STERLING RANCH - STERLING RANCH ROAD

STREET IMPROVEMENT PLAN

CDR-20-005

Engineering Review
10/30/2020 10:54:35 AM
dsdrice
JeffRice@elpasoco.com
(719) 520-7877
EPC Planning & Community Development Department

SECTION A
STA 0+93 TO STA 2+46±
SCALE: NTS

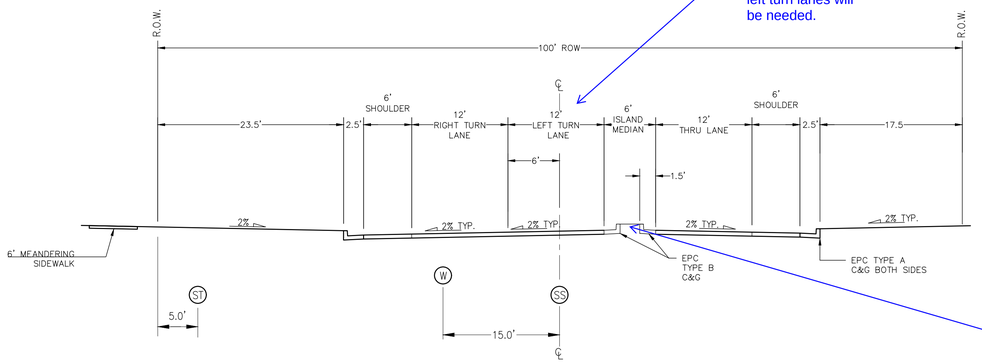
Verify that the length of this left turn lane will be adequate or if two left turn lanes will be needed.

SECTION B
STA 2+46± TO STA 4+60±
SCALE: NTS

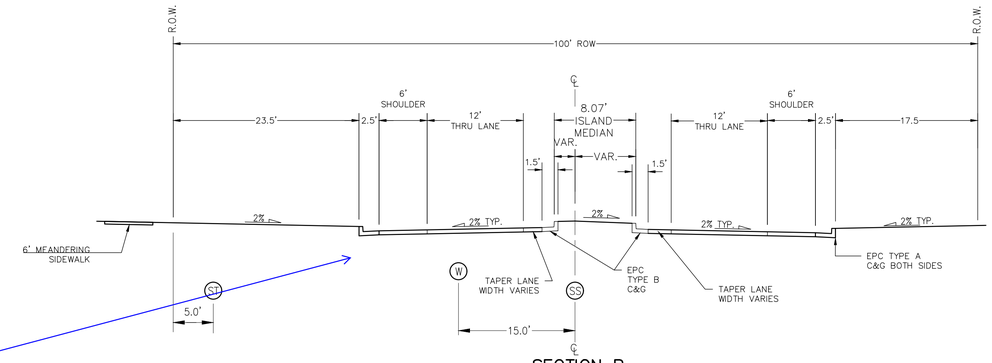
doesn't match preliminary plan

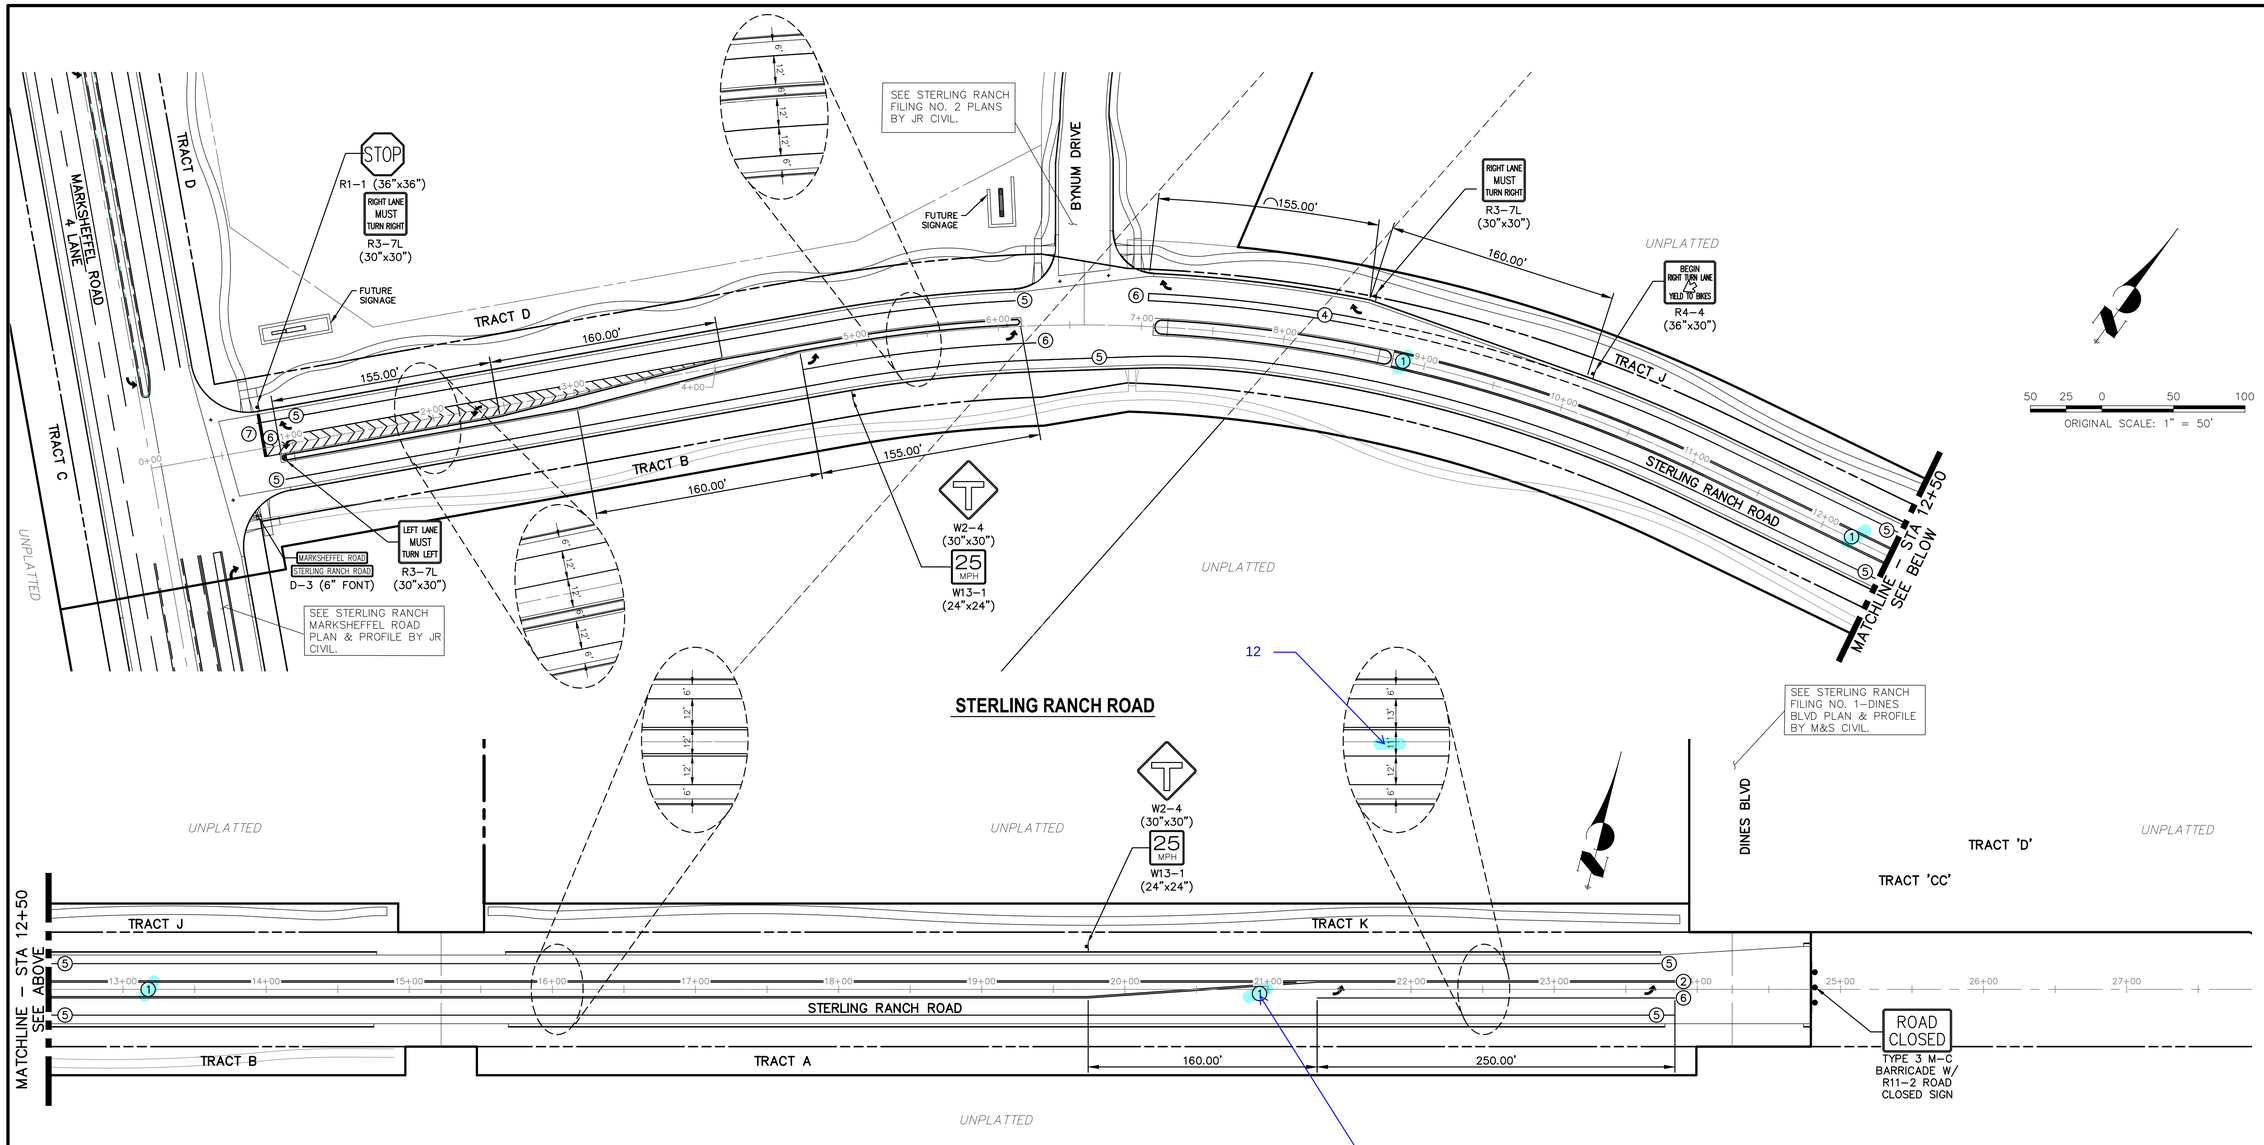
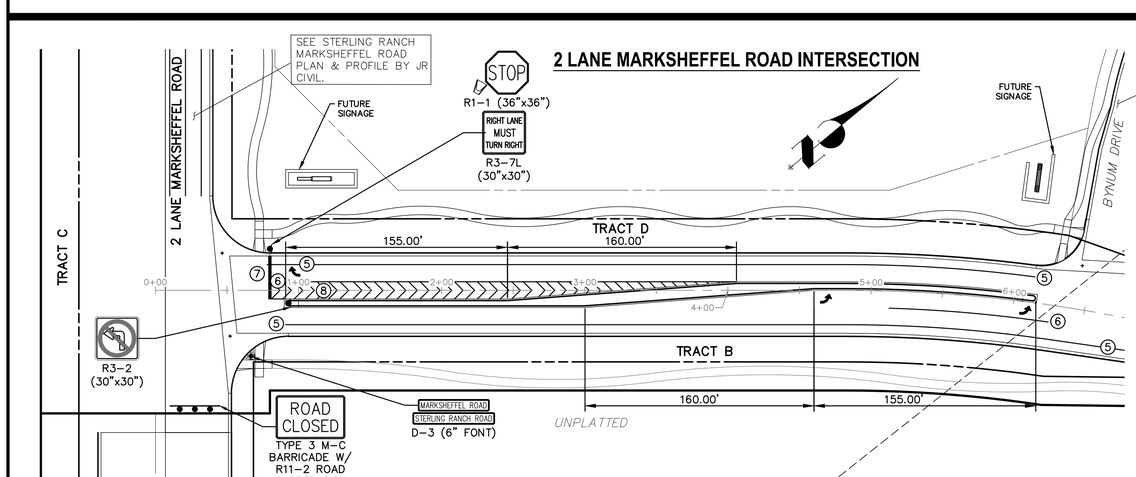
Coordinate all "1"s / "2"s

SHEET 8 OF 14

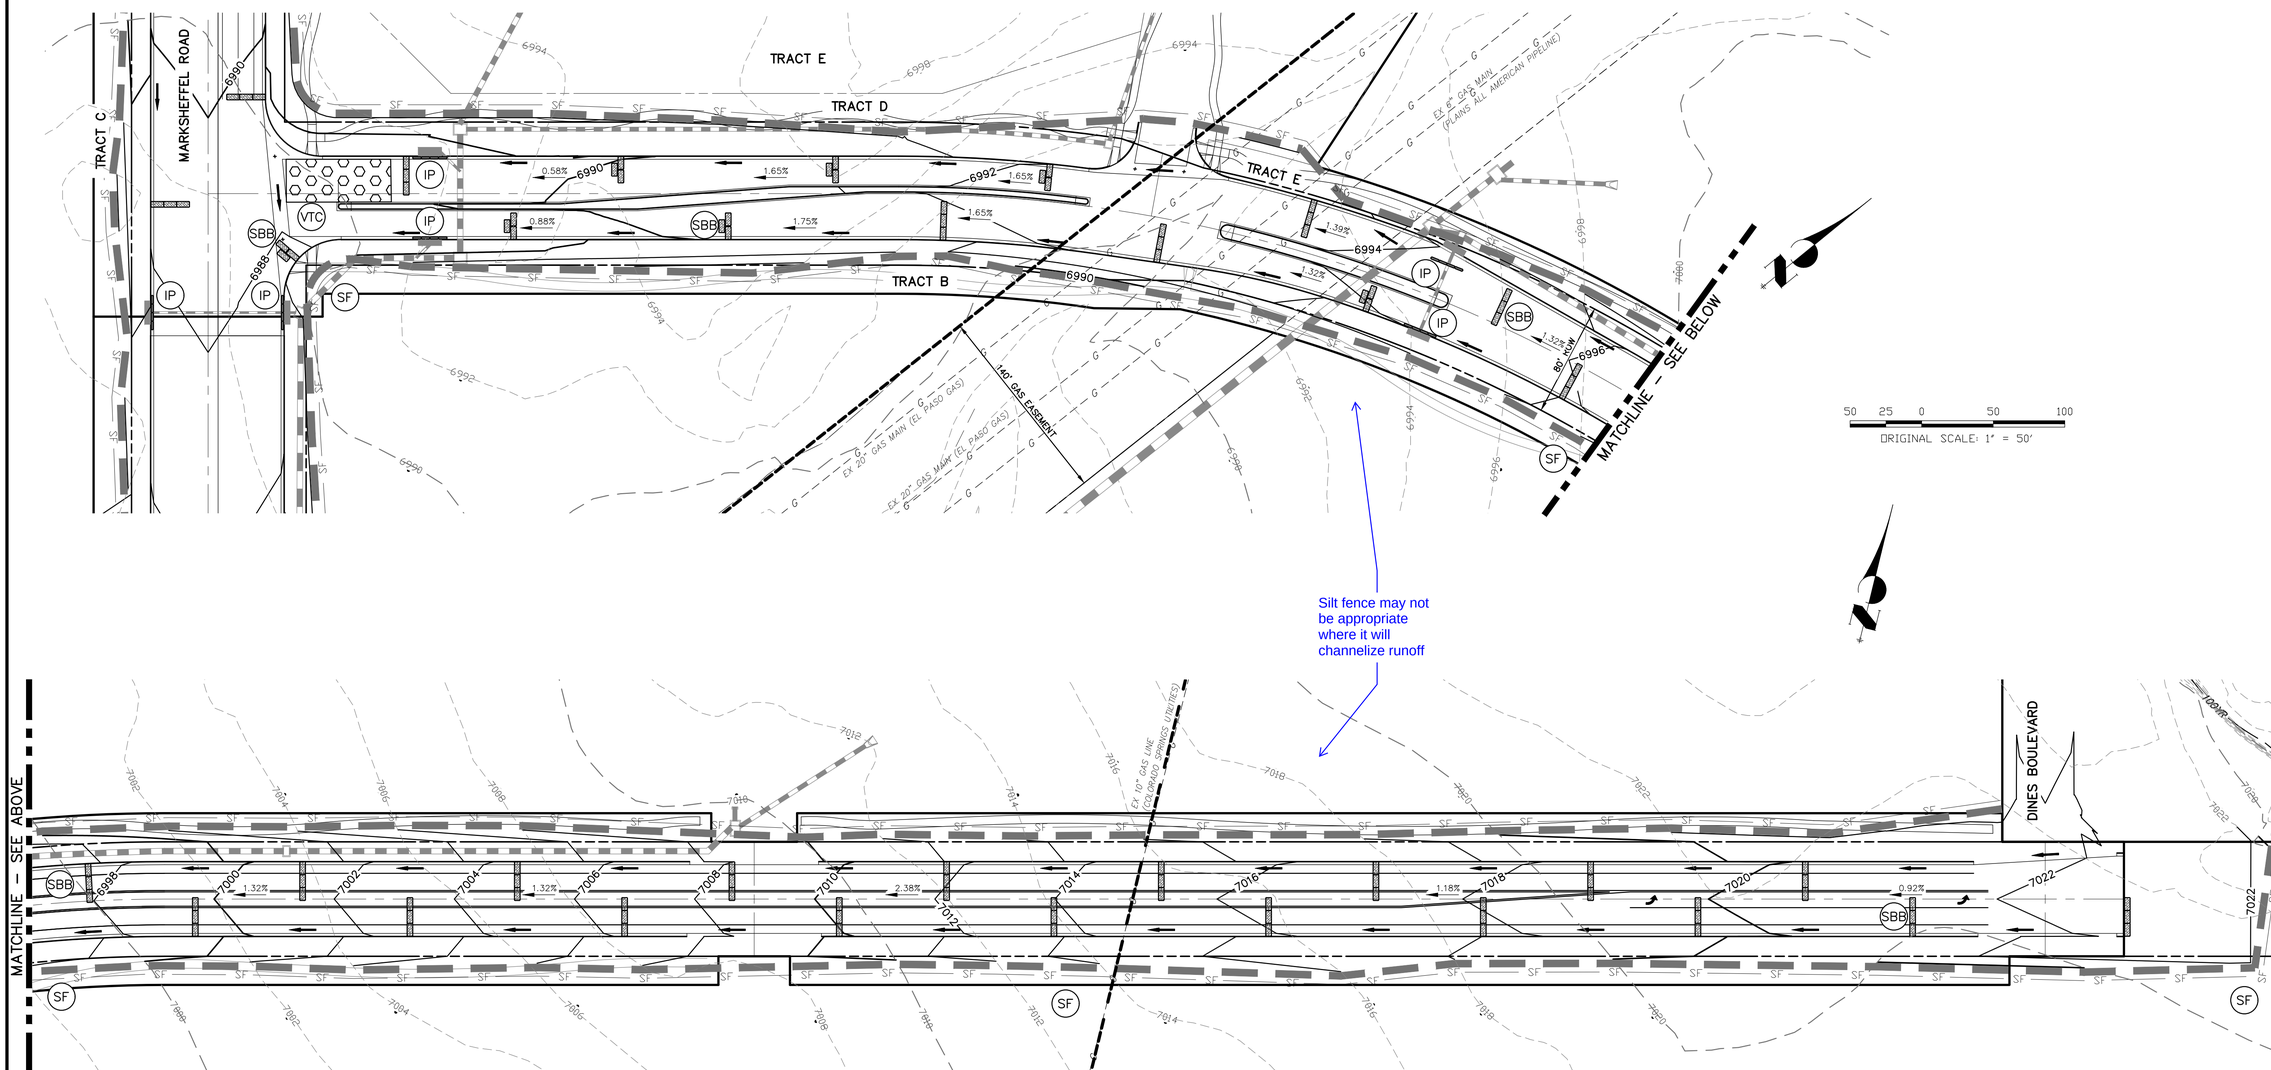
Silt fence may not be appropriate where it will channelize runoff
